EAST GRAND SCHOOL DISTRICT
Fraser Valley Elementary School
Renovation Summer 2026

1	03/05/2026	Addendum 01
No.	Date	Revision

Project Name
Fraser Valley Elementary School
Renovation Summer 2026

Project Number	
222000.50	
Date (YYYY/MM/DD)	
2026/02/11	
Drawn By	Checked By
GW	KA
Drawing	
GENERAL INFORMATION AND SHEET INDEX

MD-111A

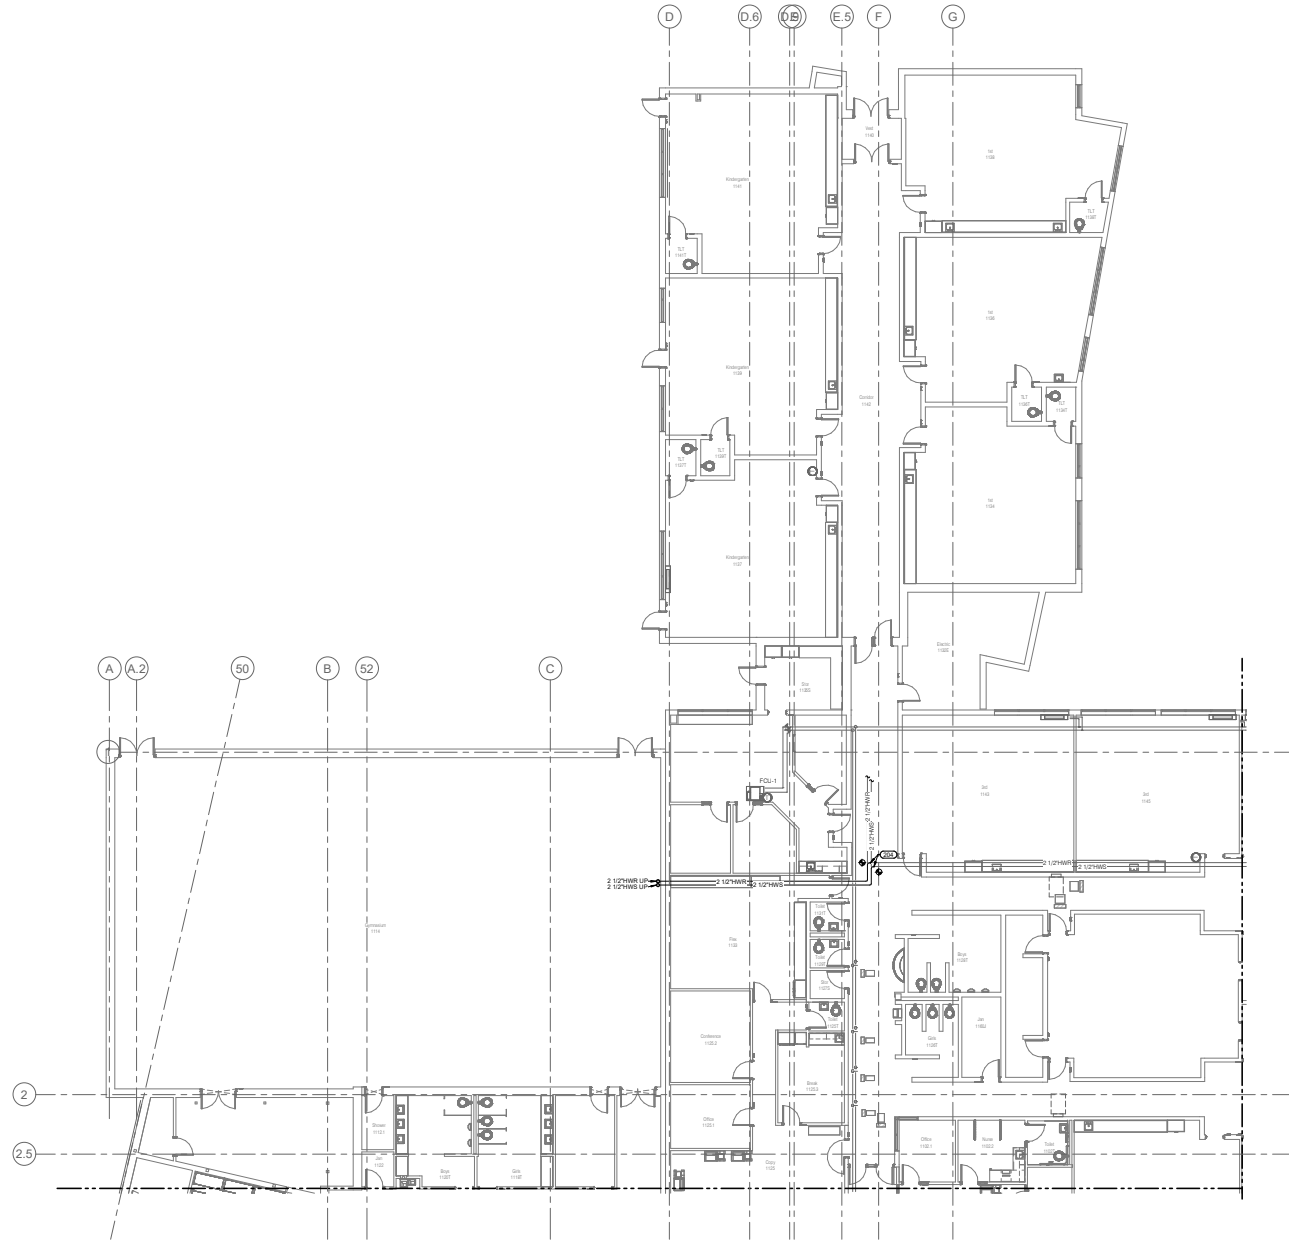
115
ALTERNATE OR DISCONNECT EXISTING HWS & HWR FROM EXISTING BOILER B-3 FROM HIGH-ABR PIPING FROM PUMPS P-7 AND P-8 SERVING 10 NORTH WING ADDITION.

M-121A

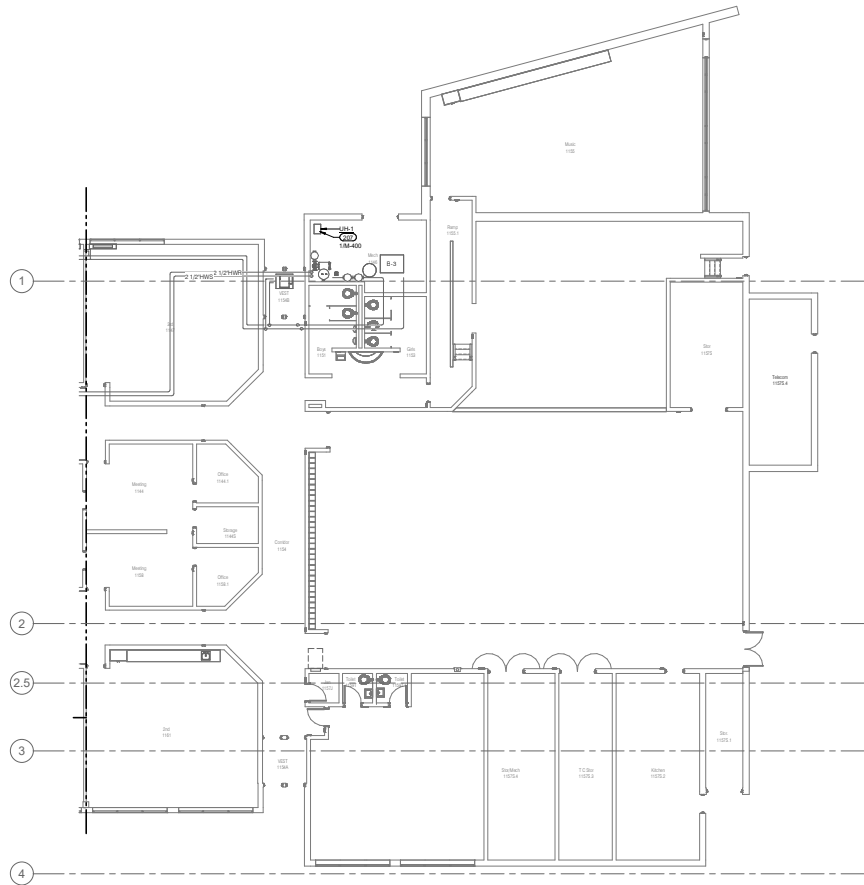
004 ALTERNATE DE. CONNECT TO AND EXTEND EXISTING HWB & HWB PIPING FROM EXISTING SOLDER B-3 AS SHOWN.

M-121C

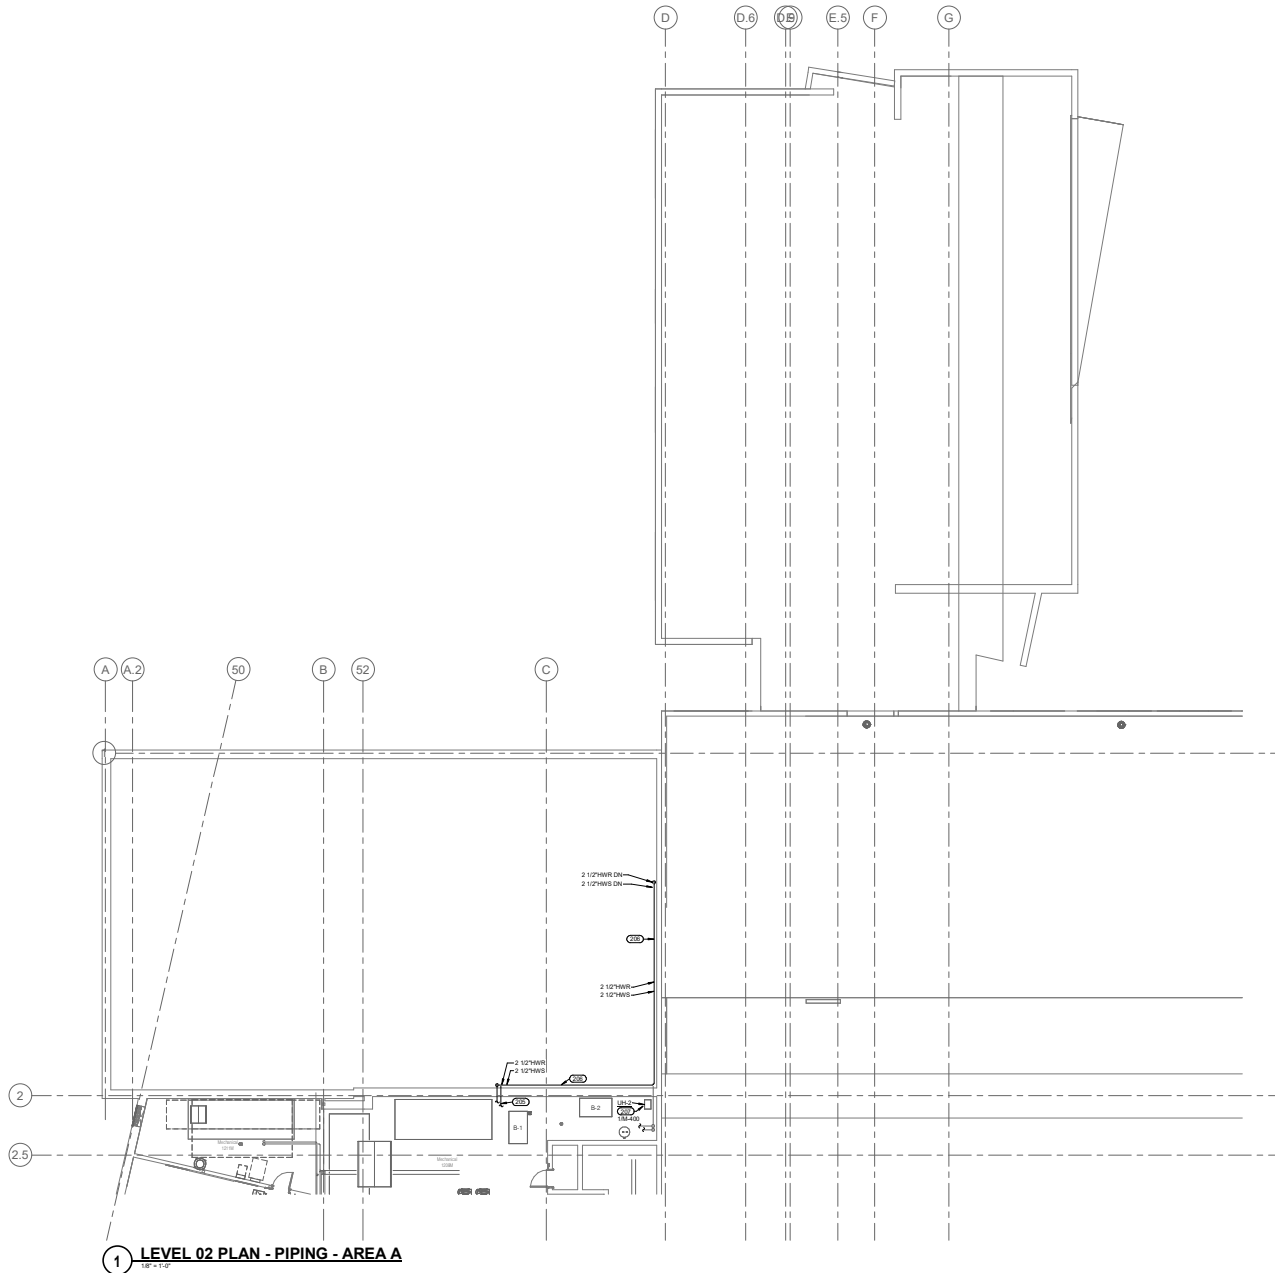
07 ALTERNATE OR PROVIDE AND INSTALL HYDRONIC UNIT HEATER. CONNECT INTO NEAREST HOT WATER SUPPLY AND RETURN PIPES. SEE SCHEDULE AND DETAIL.

M-122A

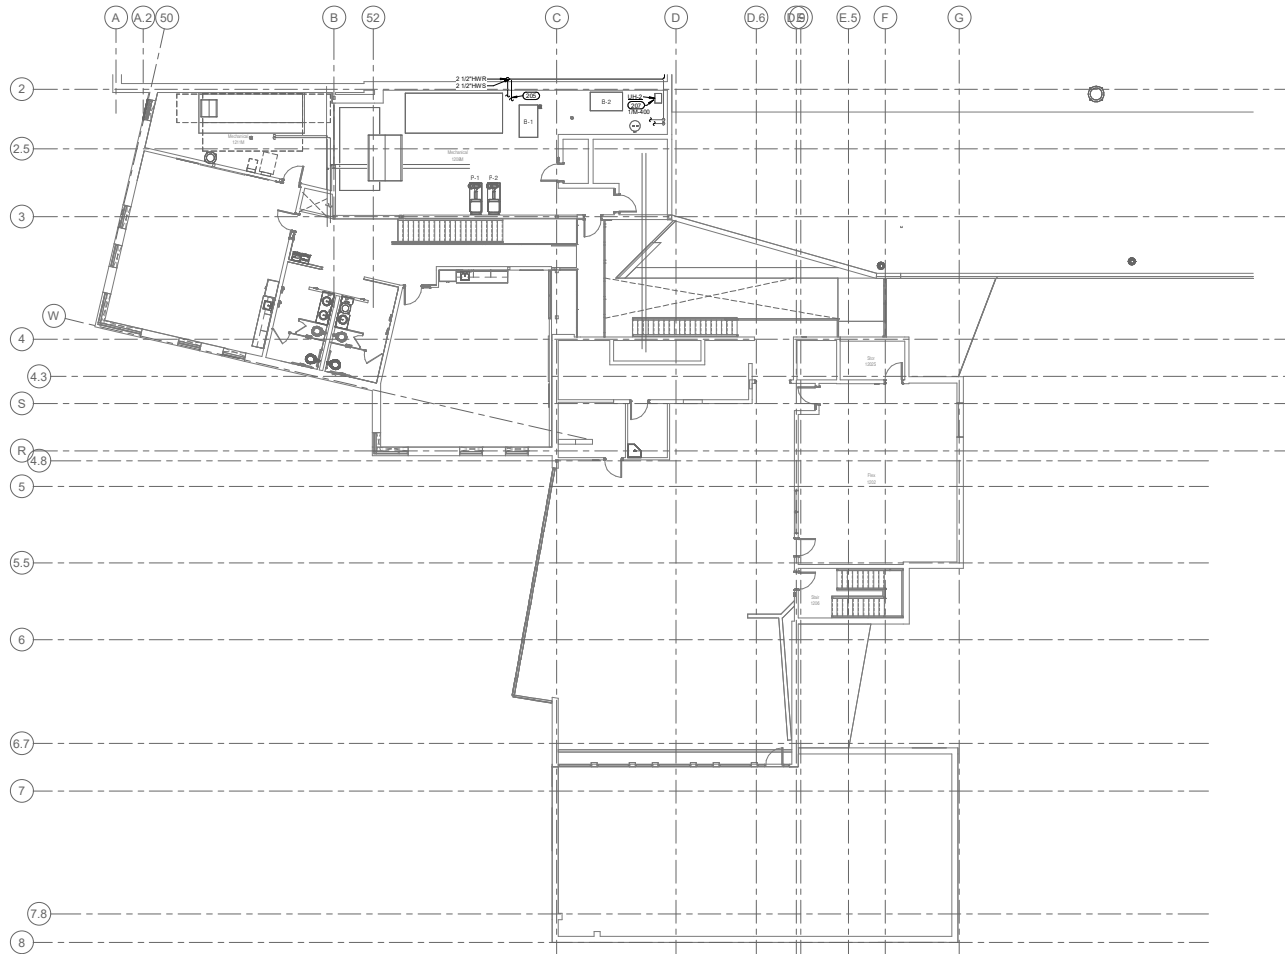
105 ALTERNATE SE CONNECT TO NEW LINE & HYD CHANGES VALVES. REFER TO HEATING WATER FLOW AND CONTROL DIAGRAM FOR ADDITIONAL DETAILS.

106 ALTERNATE OR PIPING IN CHIMNEY SHALL BE ROUTED AS HIGH AS POSSIBLE AND SHALL BE ALUMINUM JACKETED WHERE EXPOSED TO PRETECT FROM DAMAGE.

107 ALTERNATE SE PROVIDE AND INSTALL HYDRONIC UNIT HEATER. CONNECT INTO EXISTING HOT WATER SUPPLY AND RETURN PIPES. SEE SCHEDULE AND EST BL.

M-601

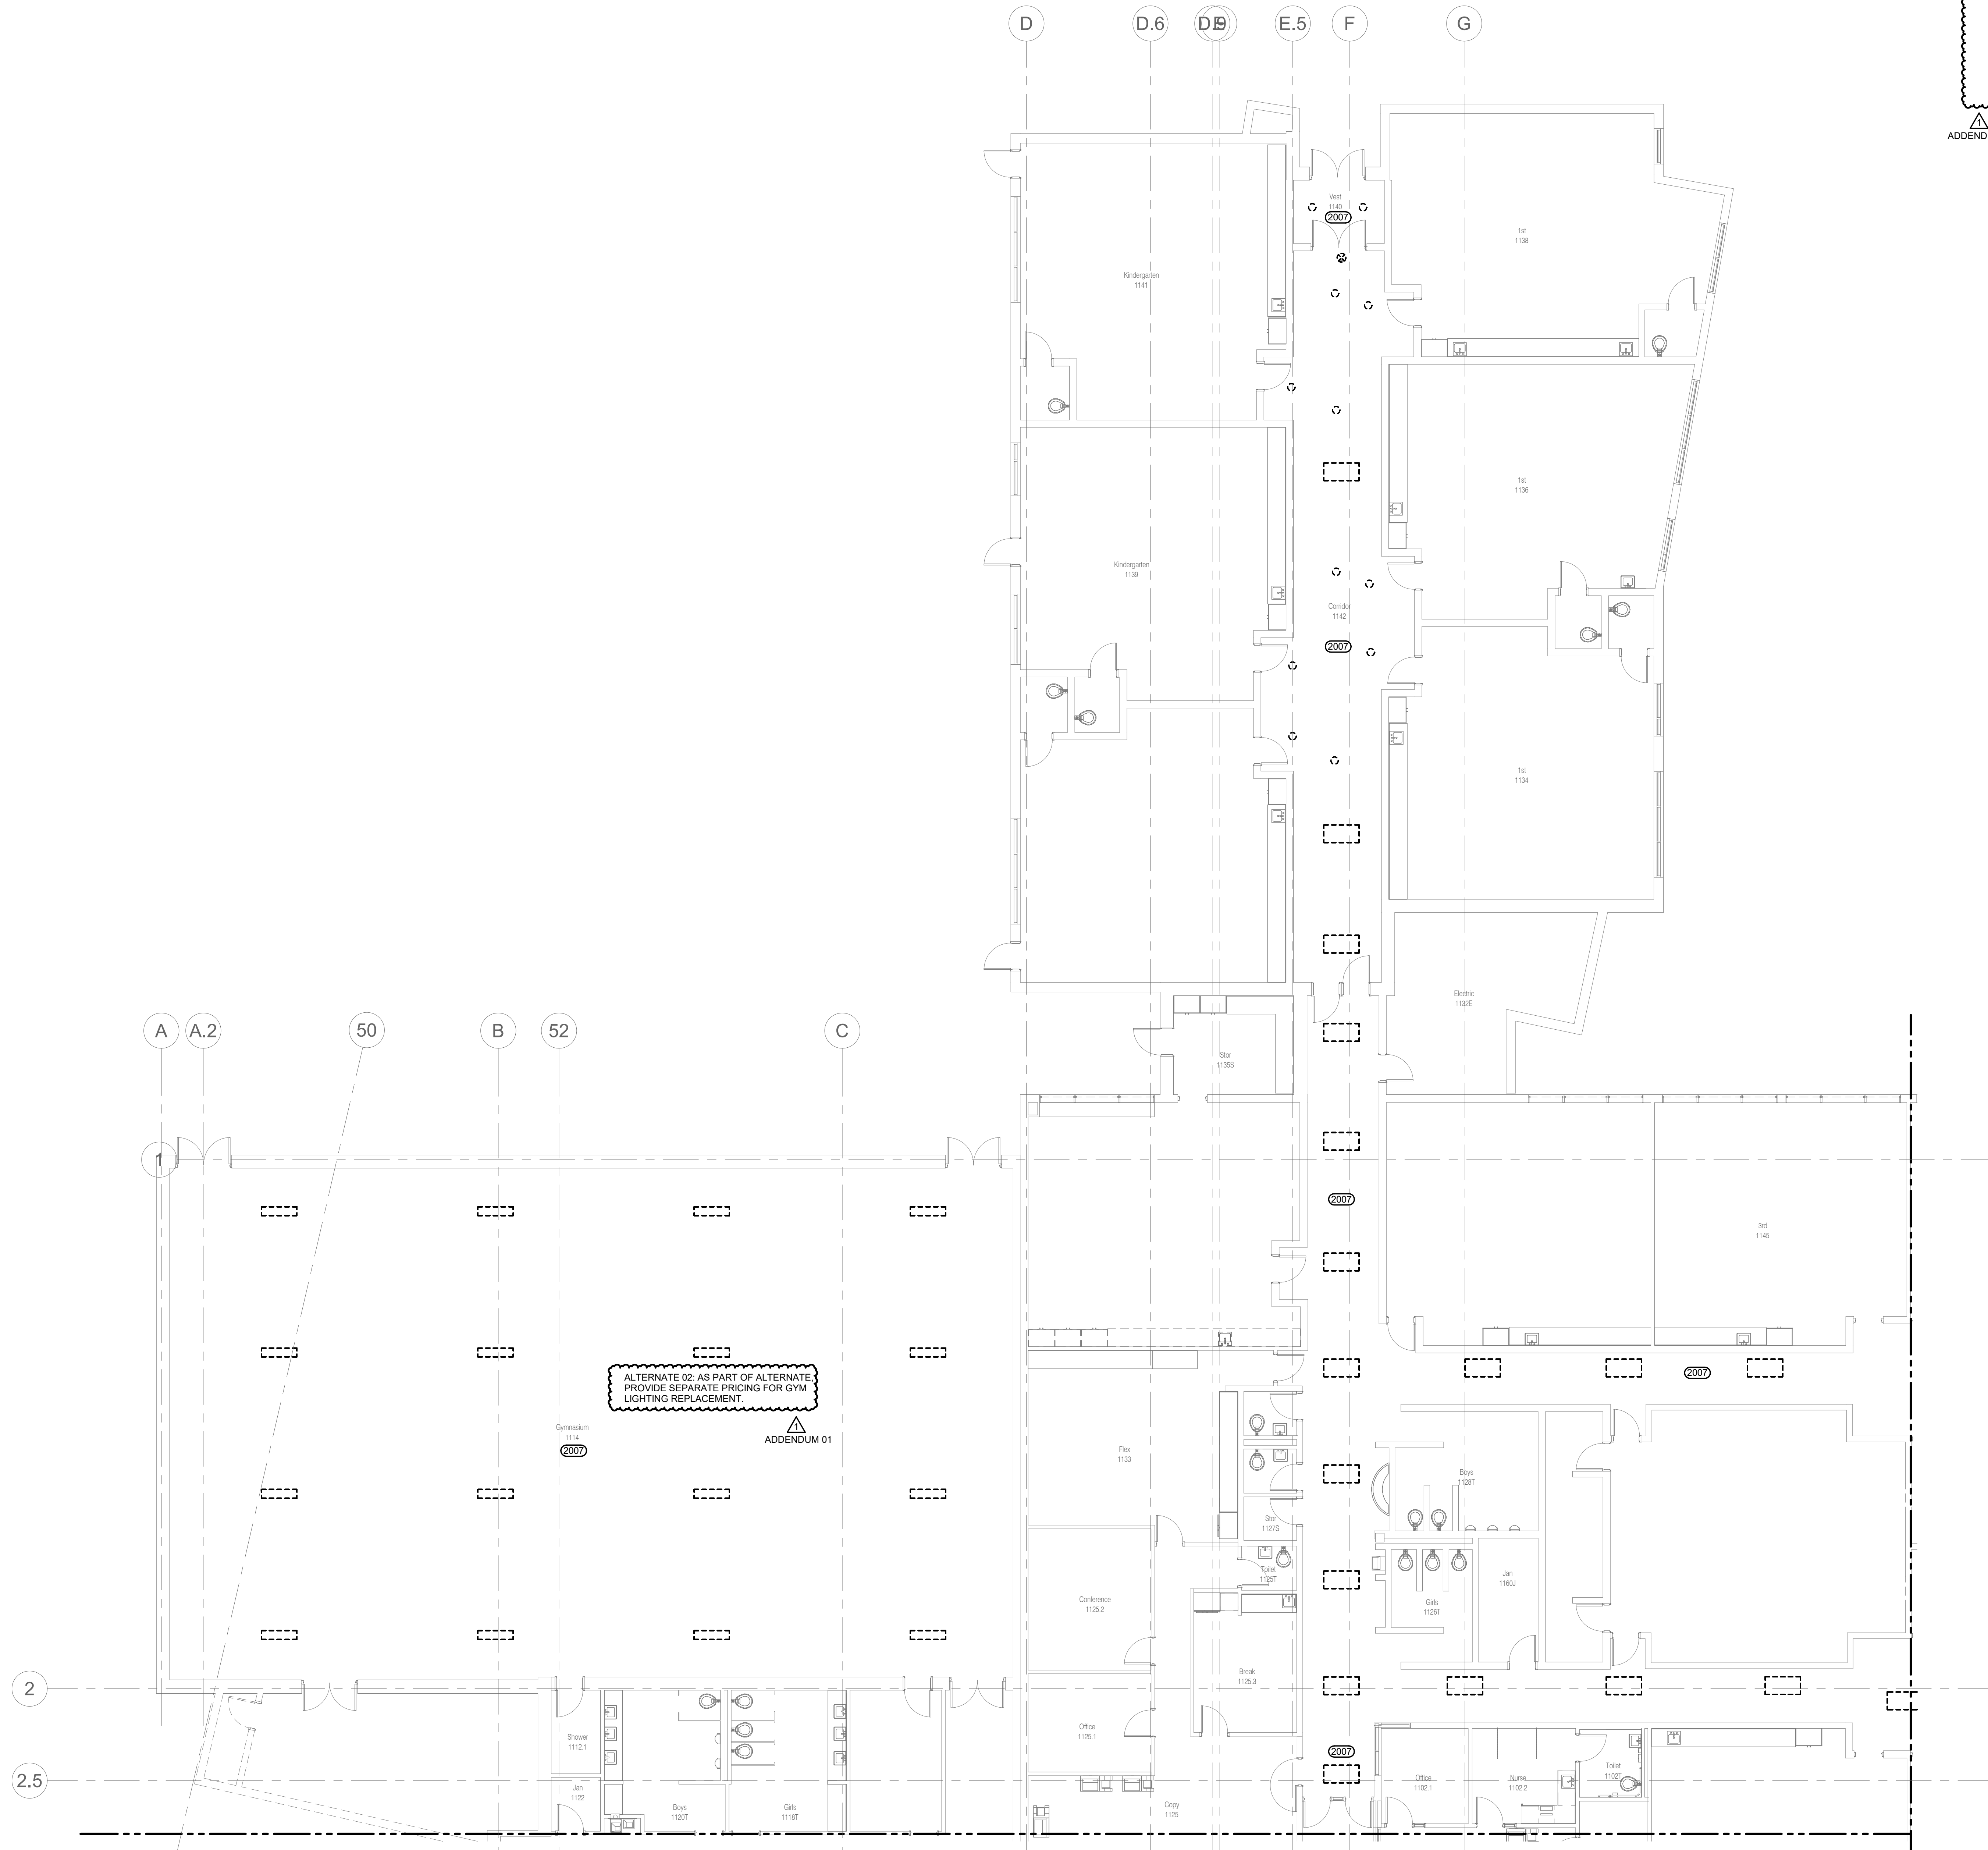
2. ALTERNATE 06																						
TAG		LOCATION			CFM	COOL				ELECTRICAL						MAXIMUM DIMENSIONS						
NAME	NAME	NO.	ALTITUDE	ARRANGEMENT	DESIGN	FLUID / GLYCOL %	GPM	ENT %	WLT %	VOLTS/PH	FLA	DISCONNECT	BY (A)	TYPE (B)	BY (A)	SCCR	LENGTH	WIDTH	HEIGHT	MANUFACTURER	MODEL	NOTES
UP-1	MECHANICAL	1148	8800	VERTICAL	340	WATER / 30% PG	9	0.7	180	120 V	1	0.8 A	MFR	NF	MFR	5,000 A	1'-11"	11"	1'-0"	MOORE	HC16	1.2
UP-2	MECHANICAL	1208	8800	VERTICAL	340	WATER / 30% PG	9	0.7	180	120 V	1	0.8 A	MFR	NF	MFR	5,000 A	1'-11"	11"	1'-0"	MOORE	HC16	1.2
